ADDENDUM

ADDENDUM NO: 03

PROJECT: Center Grove HS Renovations – Package 2

DATE: September 4, 2026

DRAWING TITLE:
**MECHANICAL
SCHEDULES
AND DETAILS**

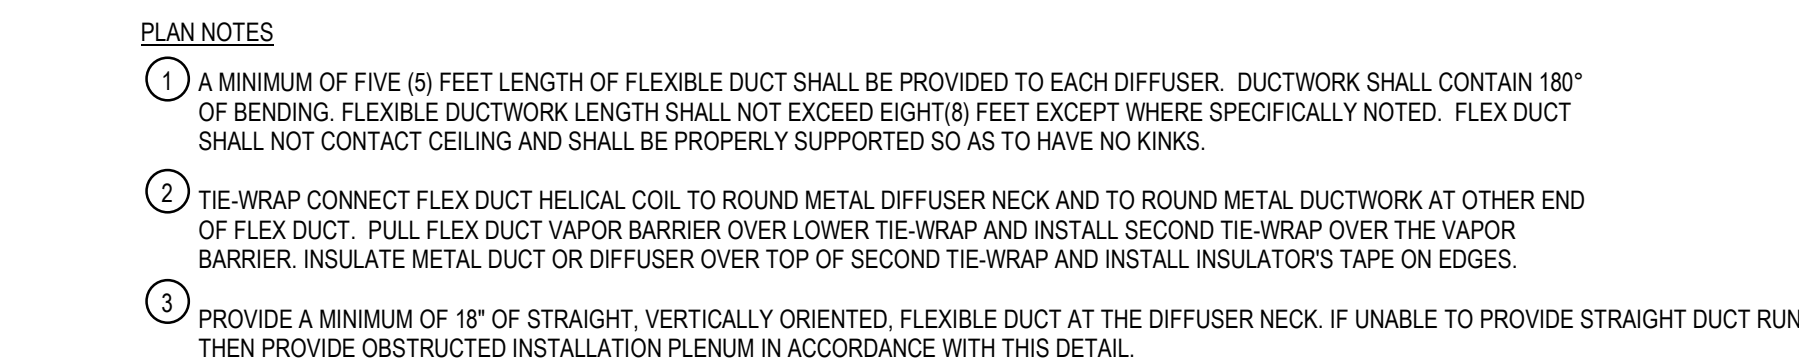
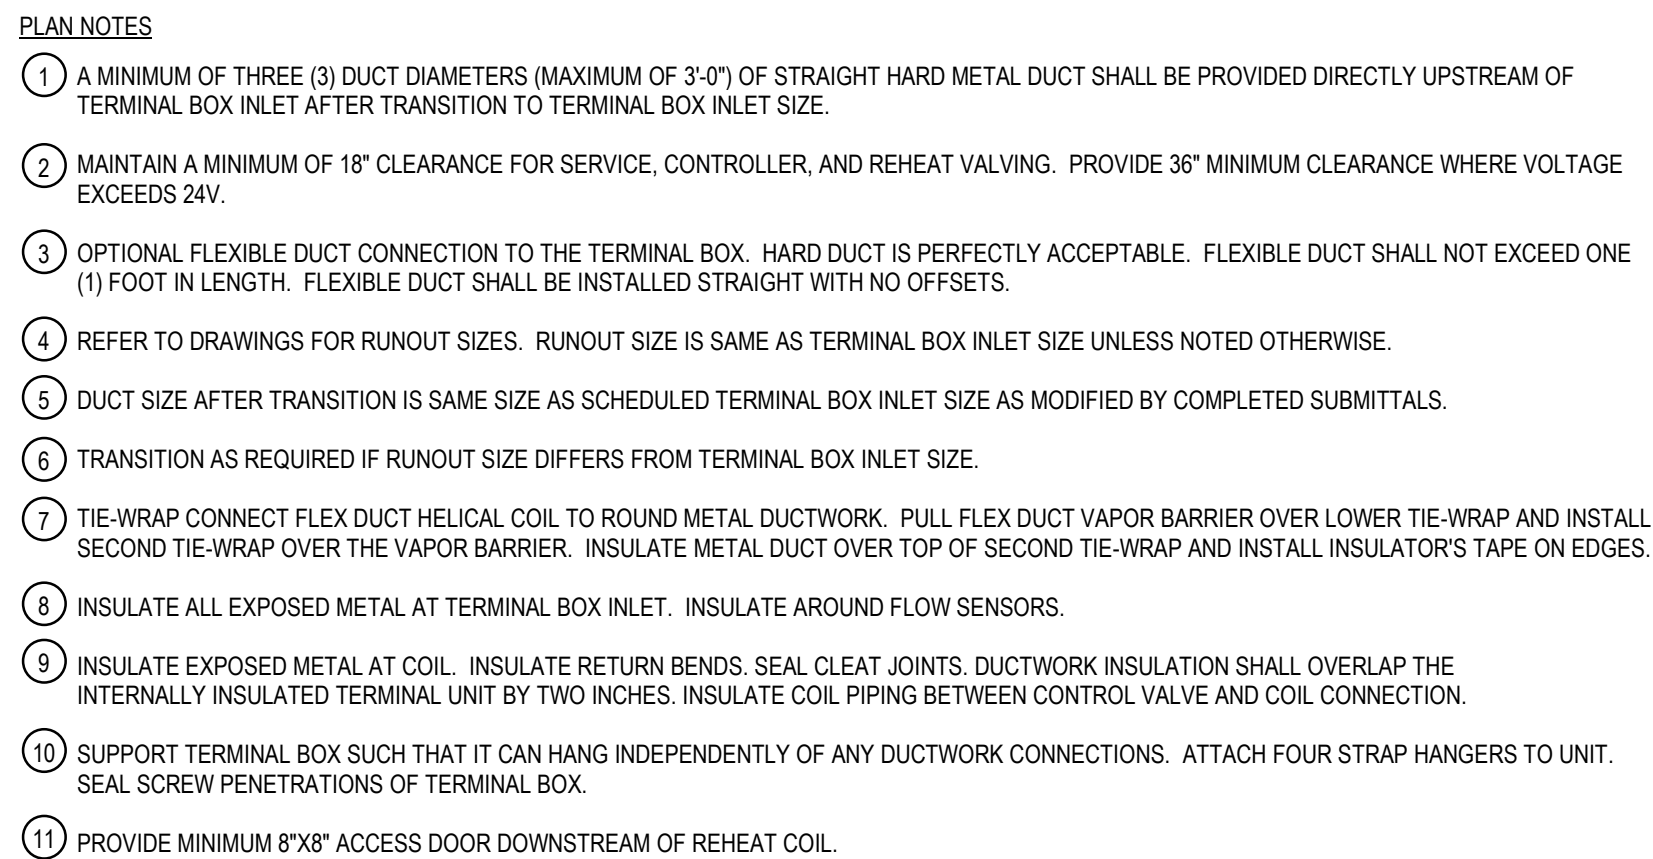
- A. Adjusted mechanical equipment to reflect new welding filtration equipment.

1 TYPICAL WALL DEVICE MOUNTING DETAIL

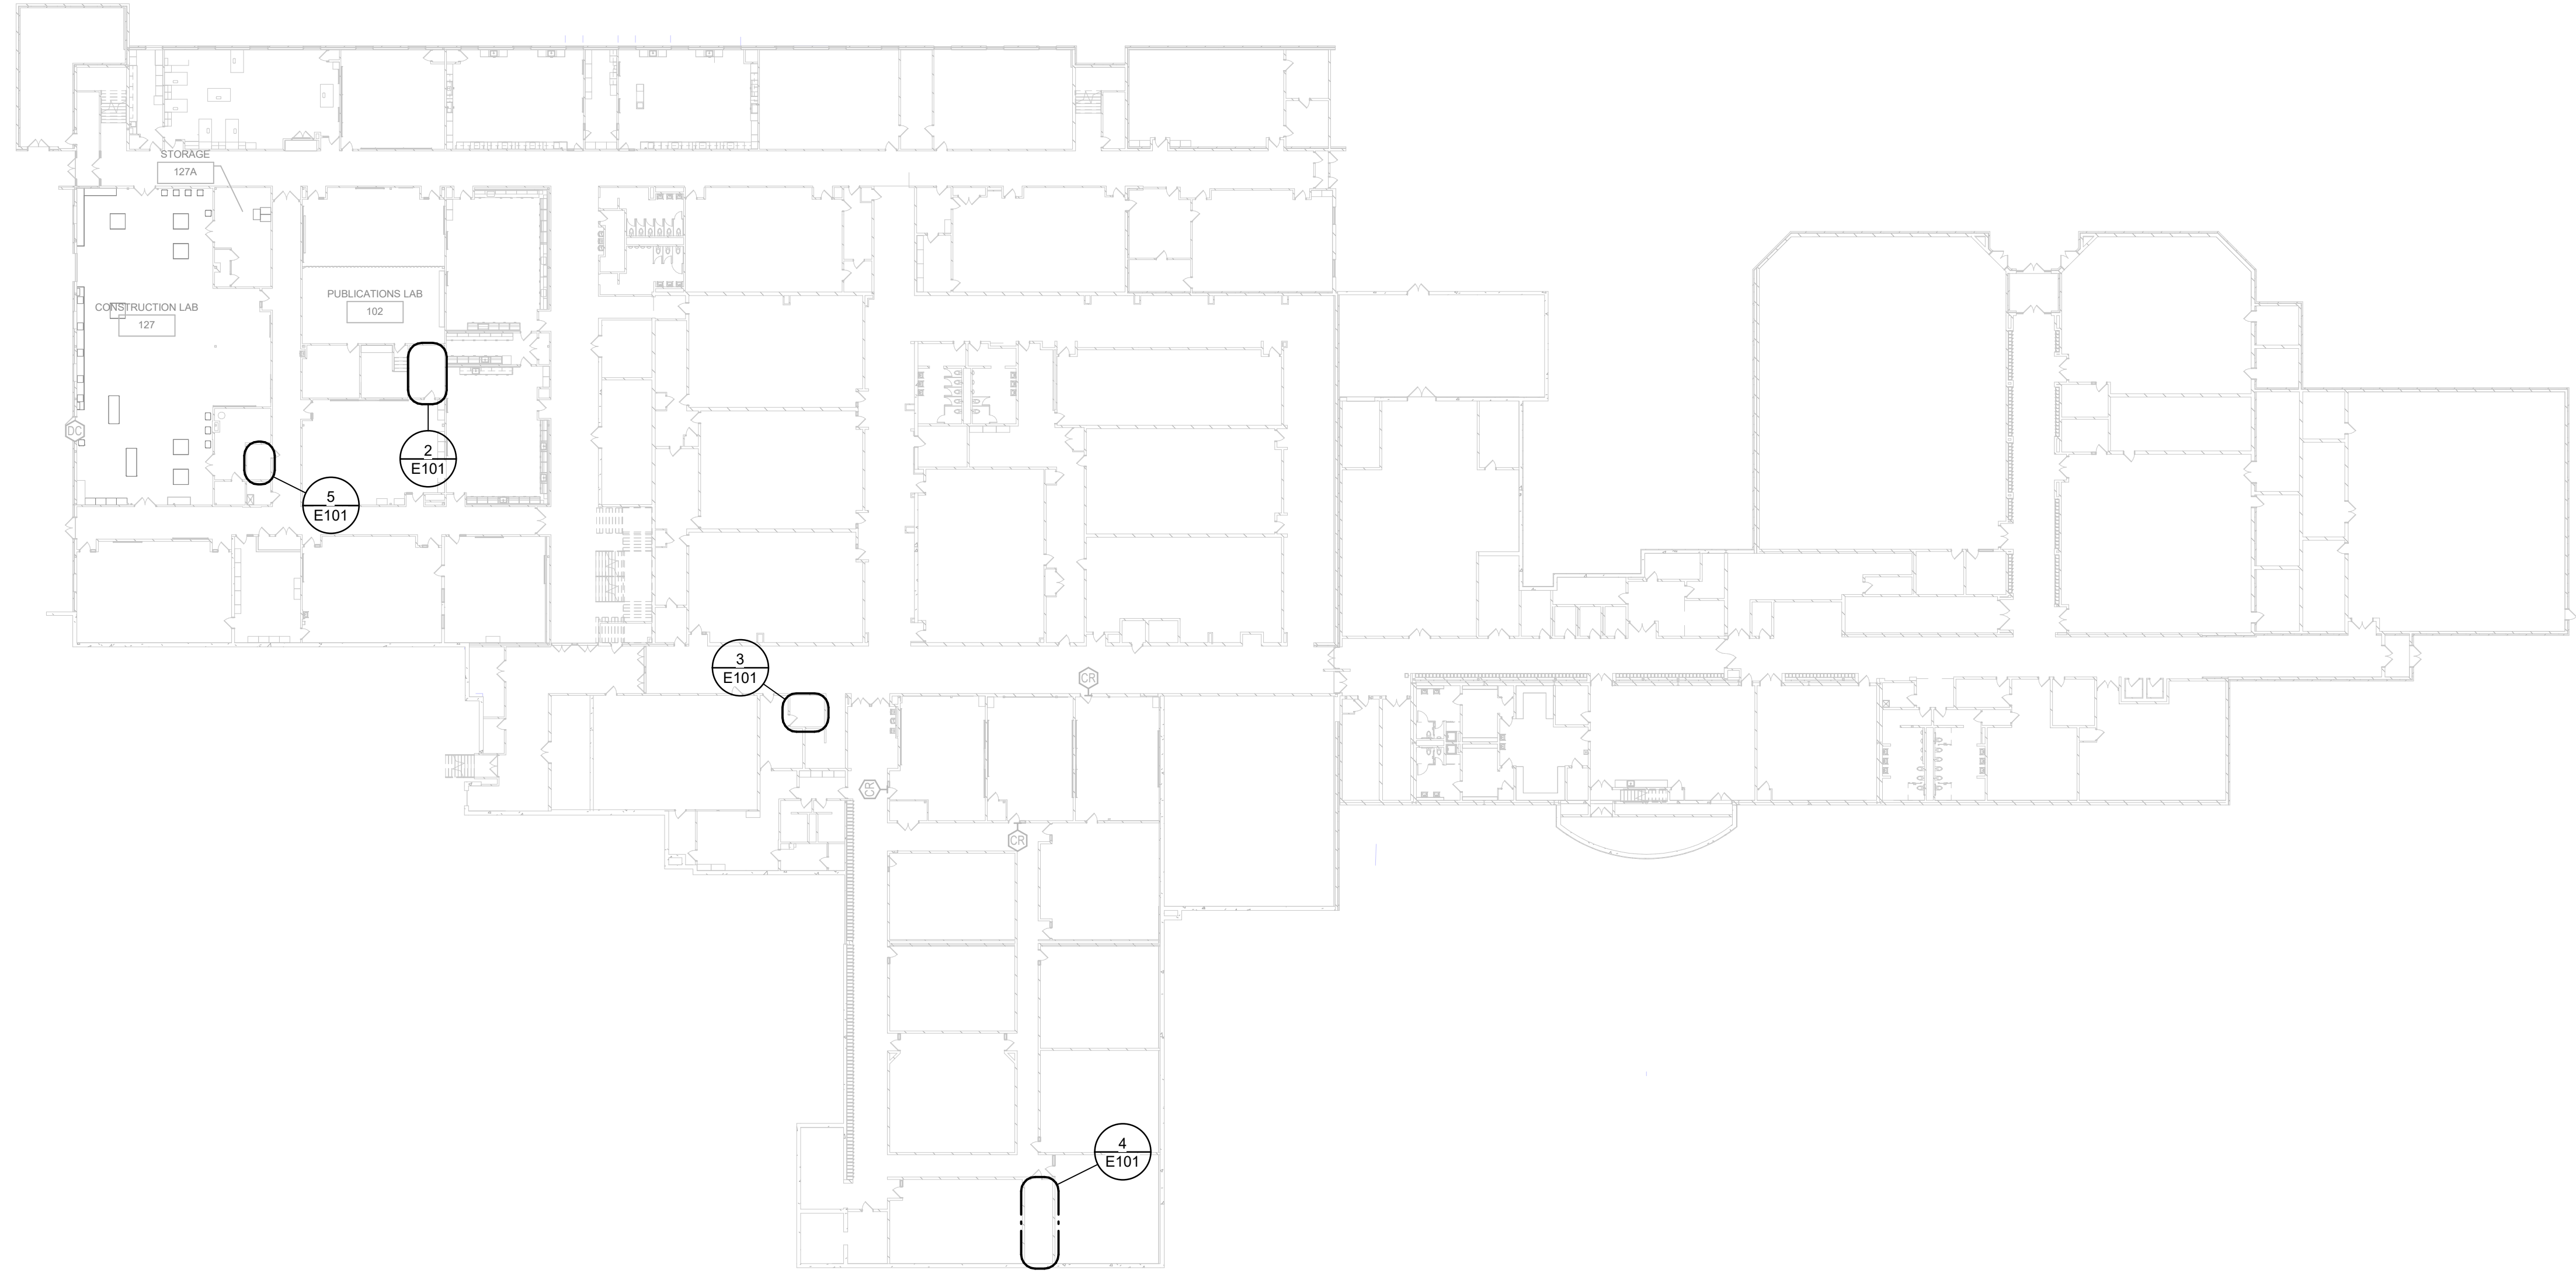
- A. Updated legend to provide space for Typical Wall Device Mounting Detail
- B. Moved Typical Wall Device Mounting Detail from sheet E400B
- C. Updated Sheet name
